**HOWELL TOWNSHIP PLANNING COMMISSION
REGULAR MEETING**

A. Old Business:
- B. New Business:
 1. Kory Leppek, PC2025-01, Parcel # 4706-20-100-027, 4640 W. Grand River Ave.
 Preliminary Site Plan Review
 2. Renewable Energy Ordinance - Discussion

Site Plan Review For Howell Township, Michigan

Applicant:	Kory Leppek
Project Name:	Leppek Landscapes
Plan Date:	December 16, 2024
Location:	4640 W Grand River
Zoning:	Industrial Flex Zone (IFZ)
Action Requested:	Preliminary Site Plan Approval

C2.0

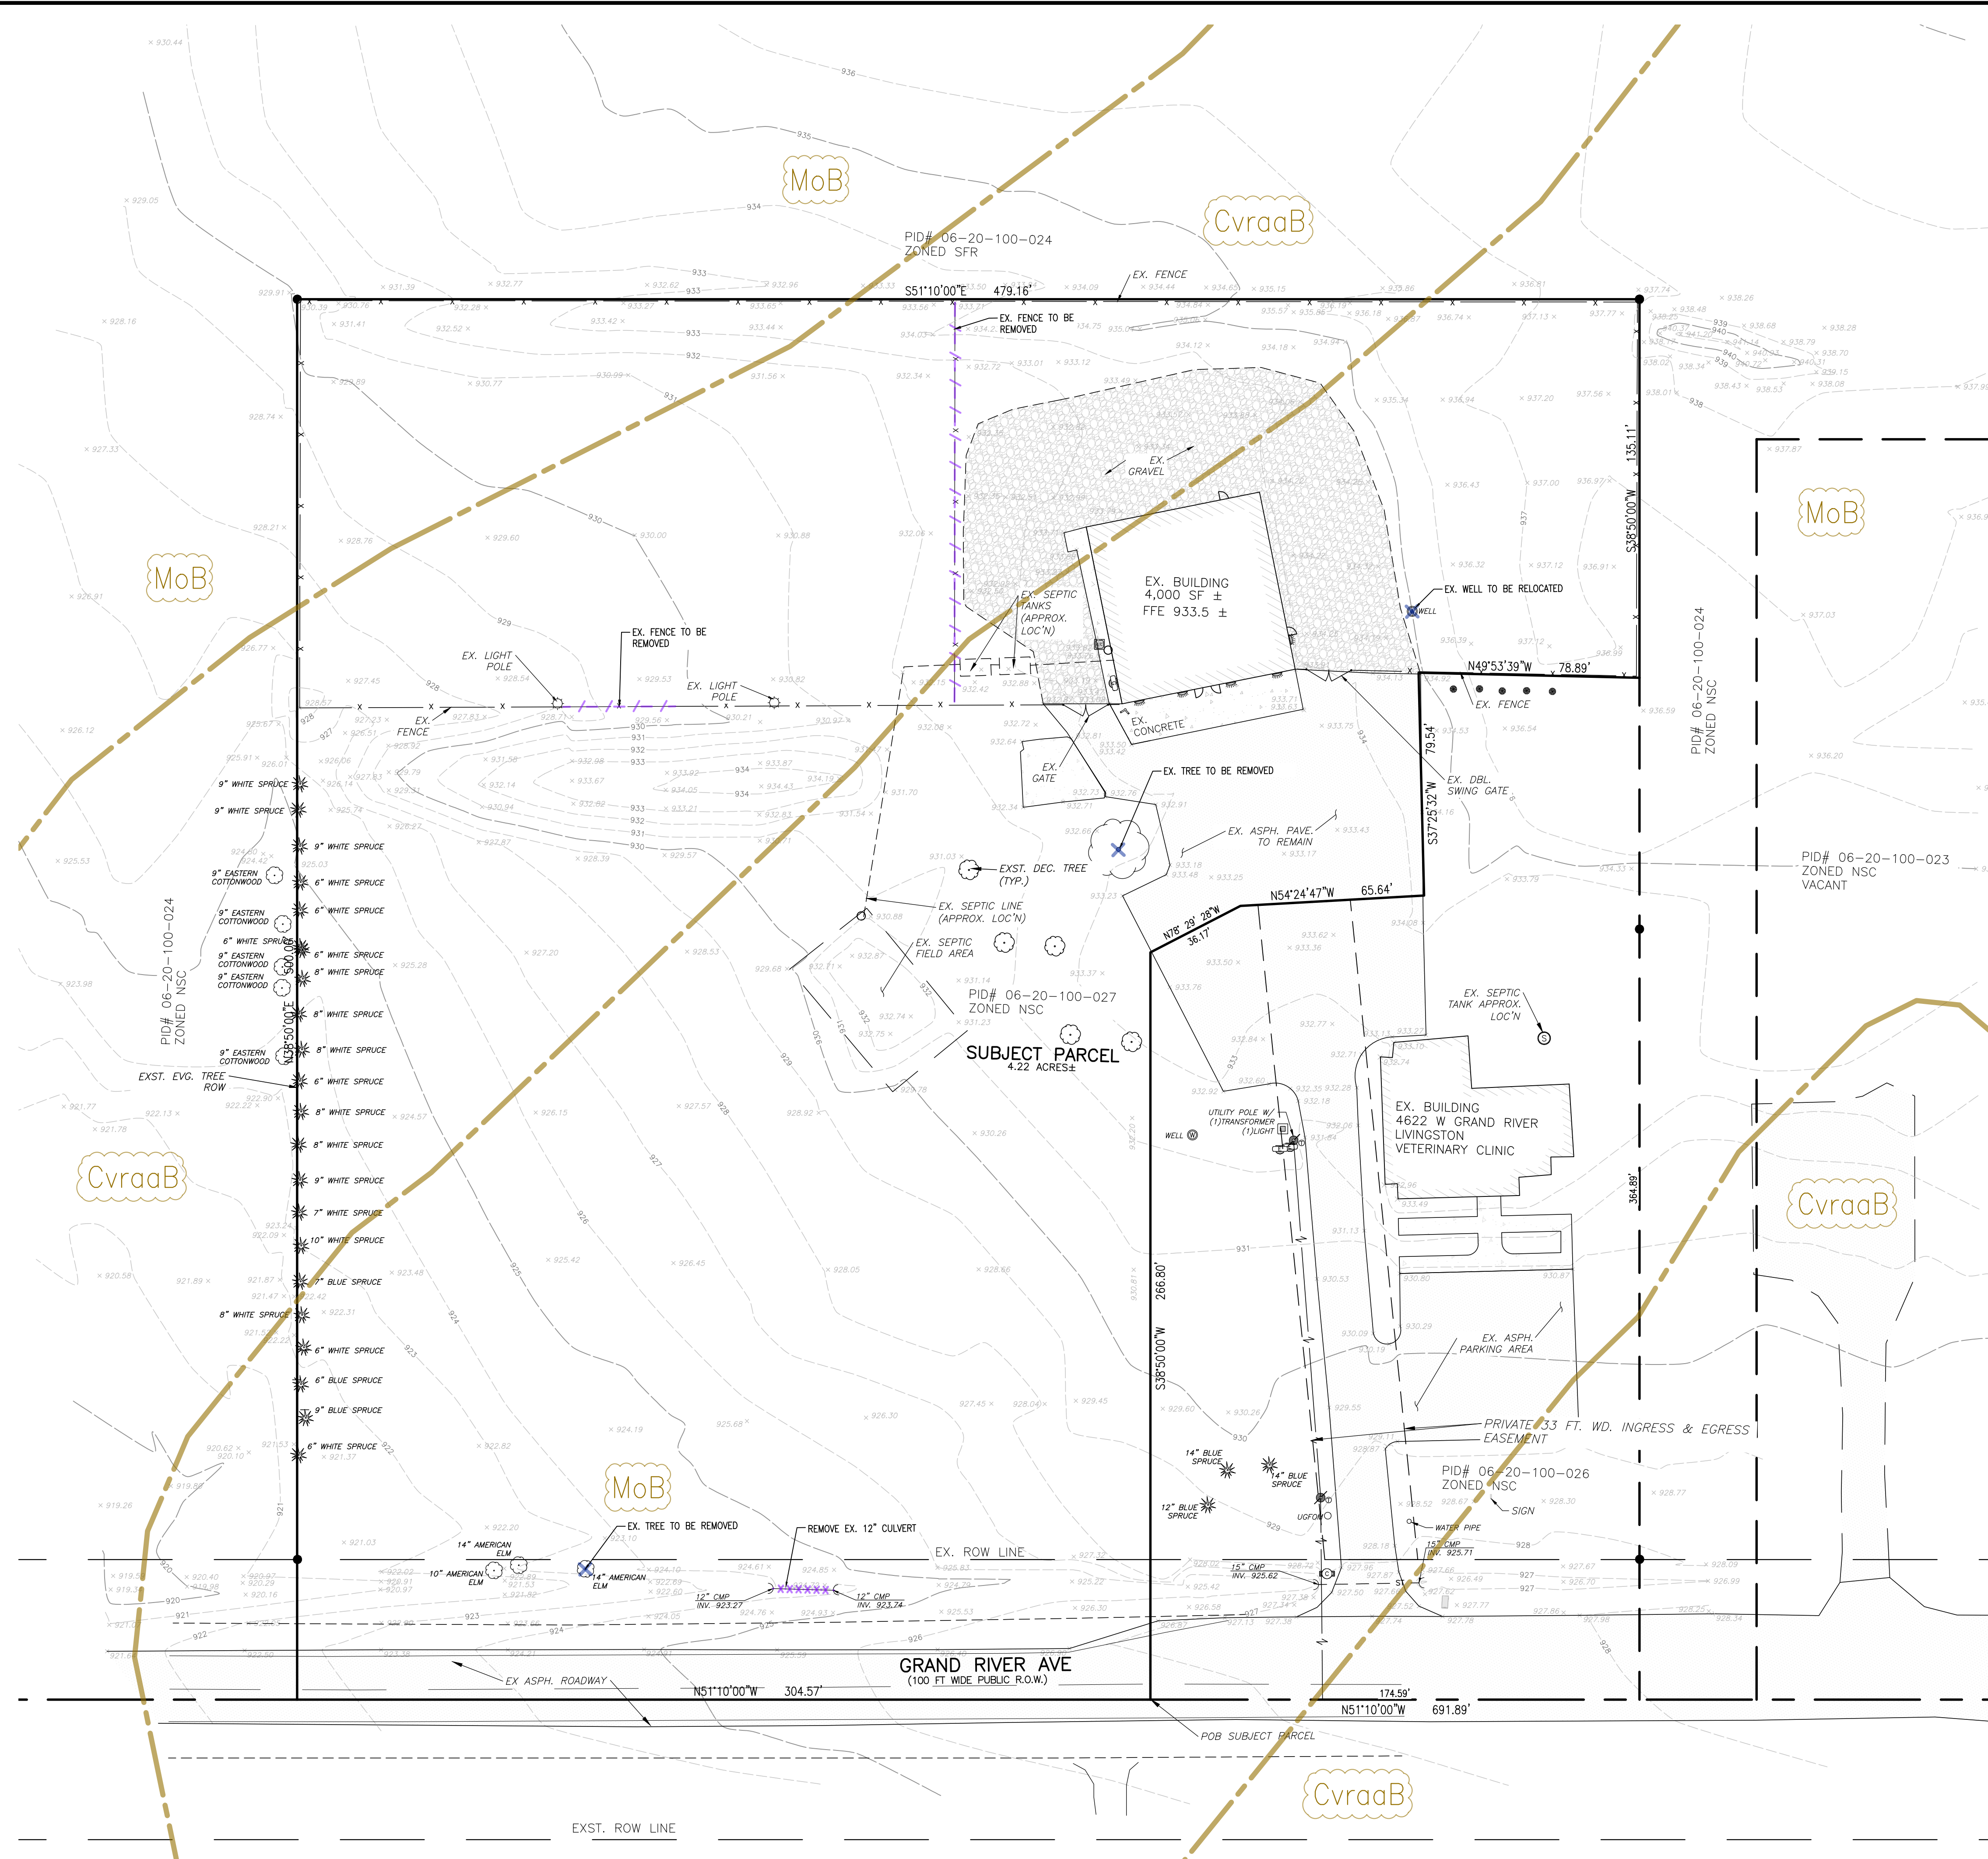
Items to be Addressed: 1) Correct Sheet C-1 to reflect updated zoning classification of IFZ. 2) Applicant to provide a detailed use description for the proposed activities for all areas of the site.

Items to be Addressed: Update required site data table on Sheet C-1 to reflect IFZ – Industrial Flex Zone zoning requirements.

LEPPEK LANDSCAPE INC.
 4640 W. GRAND RIVER AVENUE
 HOWELL TOWNSHIP, LIVINGSTON COUNTY, MI
 PRELIMINARY SITE PLAN
 STORM WATER MANAGEMENT PLAN

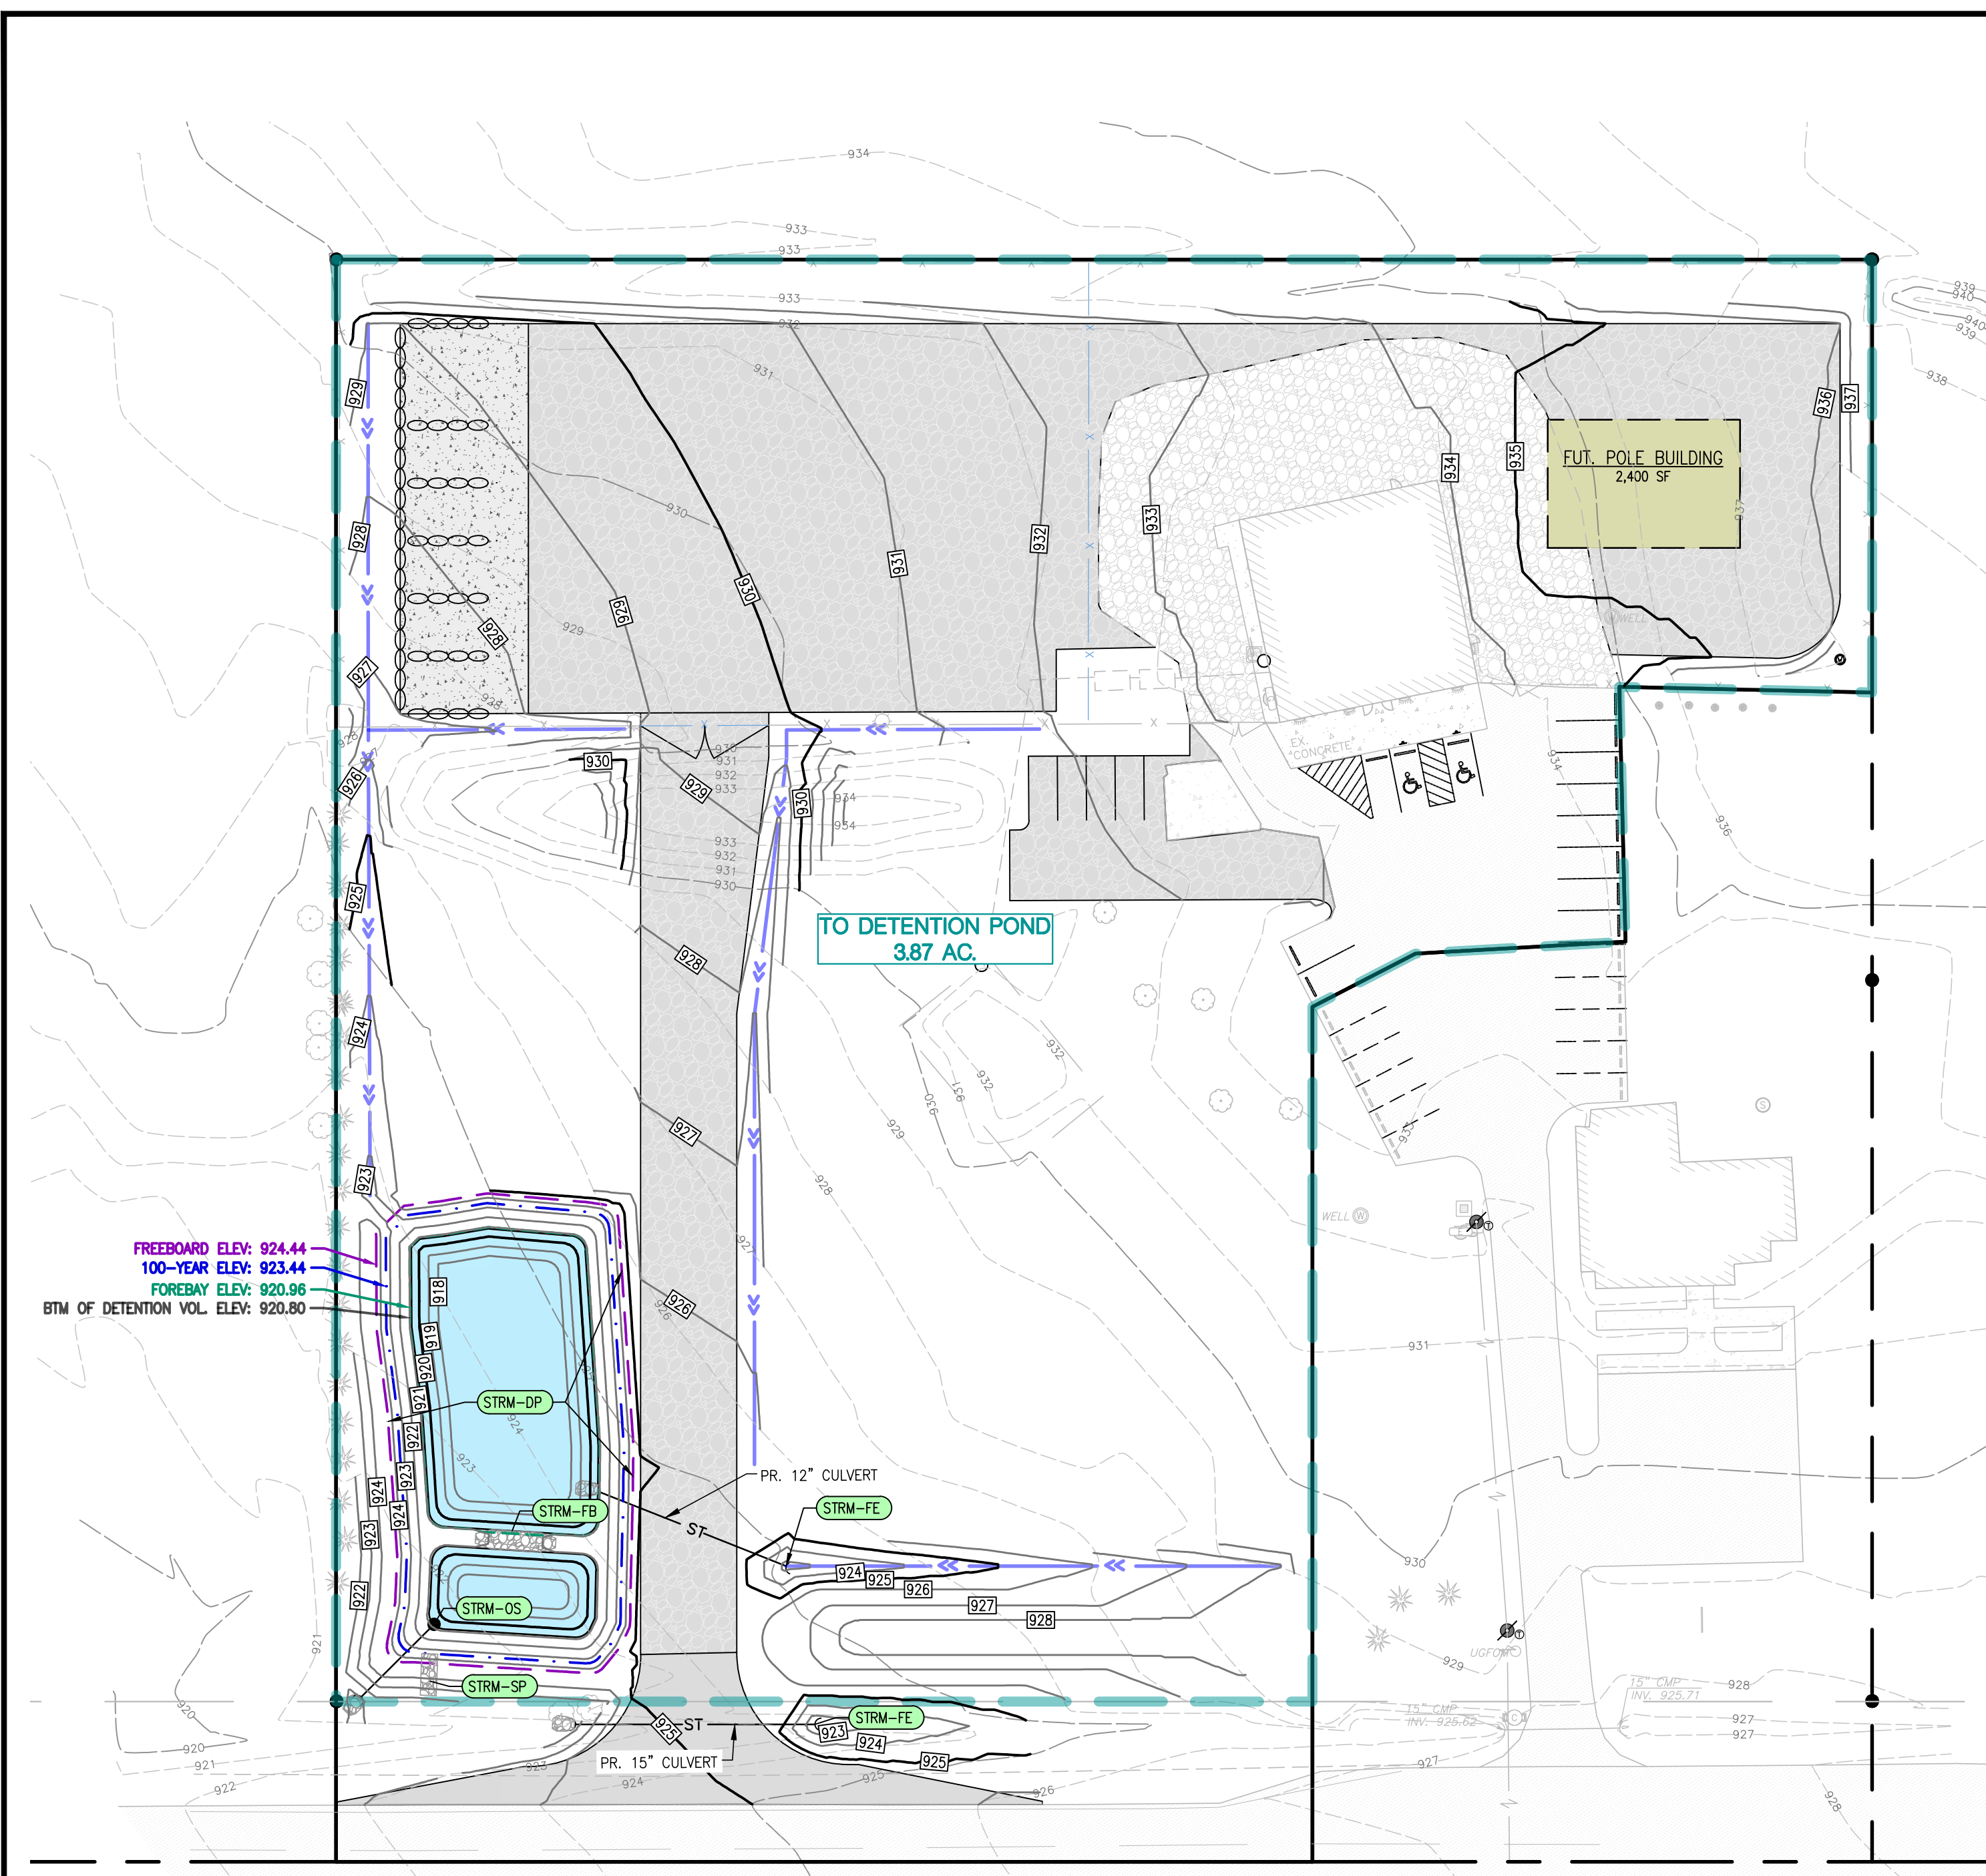
The proposed stormwater management plan for the site, as shown on sheet C6.0, indicates that stormwater will drain by sheet flow to swales along the east side of the proposed drive and the west property line. It will then flow into sedimentation and detention basins in the southwest corner of the site, which outlet to the Grand River Avenue right-of-way, which will require an MDOT permit. Drainage to the east of the proposed drive will be conveyed through a 12-inch culvert beneath the drive to reach the detention basins.
